Discretionary Review Abbreviated Analysis

Date: August 8, 2013
Case No.: **2013.0757D**
Project Address: **300 WINFIELD STREET**
Permit Application: 2013.0322.2868
Zoning: RH-2 [Residential House, Two-Family]
40-X Height and Bulk District
Bernal Heights Special Use District
Block/Lot: 5671 / 001
Property Owner: Lee & Nicole Horner
300 Winfield Street
San Francisco, CA 94110
DR Requestor: Arnold & Melinda Burgener
301 Prospect Avenue
San Francisco, CA 94110
Staff Contact: Erika Jackson – (415) 588-6363
erika.jackson@sfgov.org
Recommendation: **Do not take DR and approve as proposed**

The proposed scope of work is to construct a new roof deck on top of a 2 story addition at the rear of the single-family dwelling. The proposed roof deck would measure approximately 21.5 by 12 feet with a 42 inch open wood railing. The existing single family dwelling is partially located within the required rear yard and is therefore considered a legal noncomplying structure. No expansion of the building envelope is proposed under this permit.

Actual Versus Claimed Position of Project Sponsor Photographer
(Project Sponsor Site Section Shown in Gray)

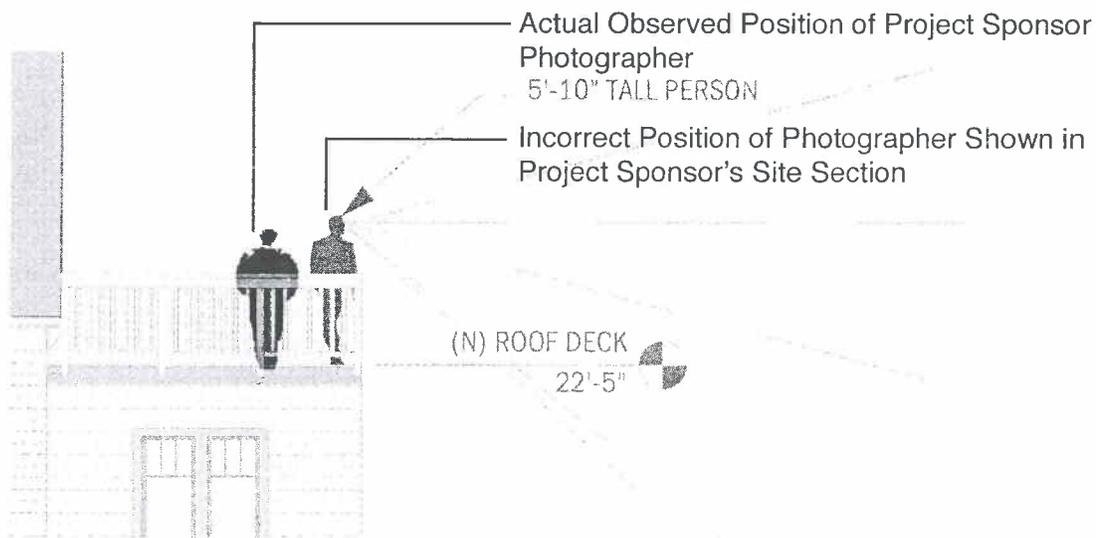
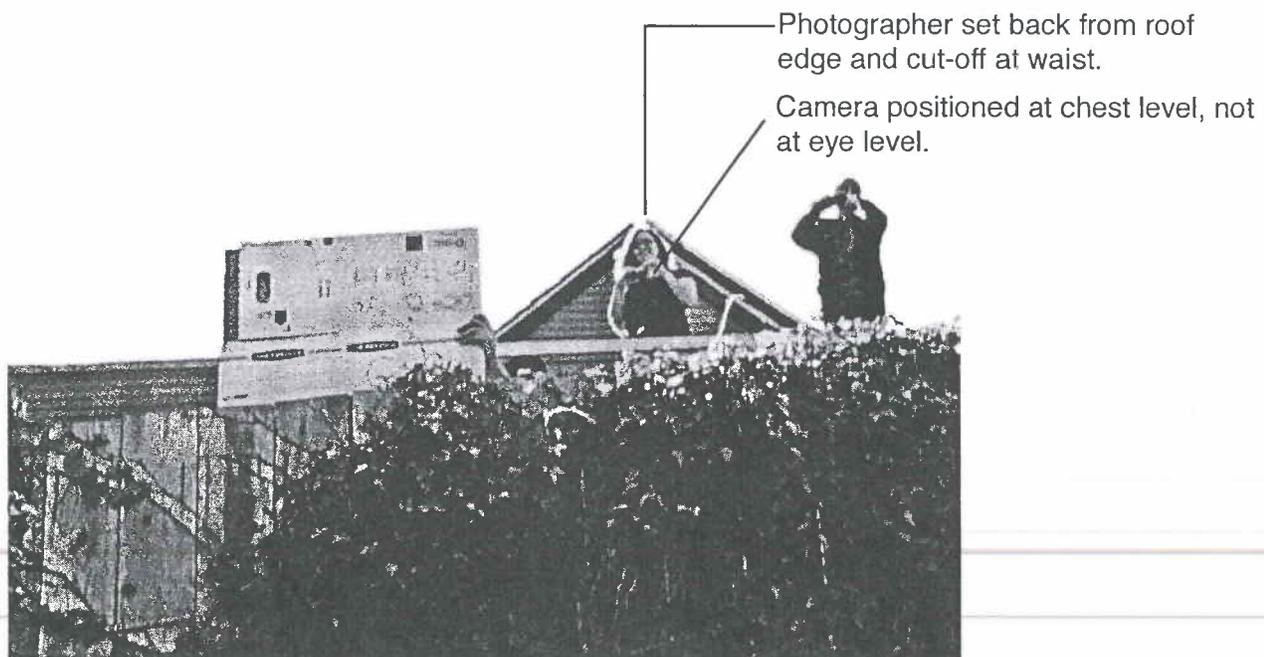
EXHIBIT 2 : DOCUMENTATION OF DISCREPANCY IN PHOTOGRAPHER'S LOCATION

The Project Sponsor photographer was observed taking photographs from a location sufficiently behind the roof edge to cut her off below the waist. The photograph shown below documents that the position of the photographer drawn at the roof edge in the Project Sponsor's Site Section is incorrect. The actual position required to cut off a body below the waist is illustrated by the black figure superimposed on the Project Sponsor Site Section above.
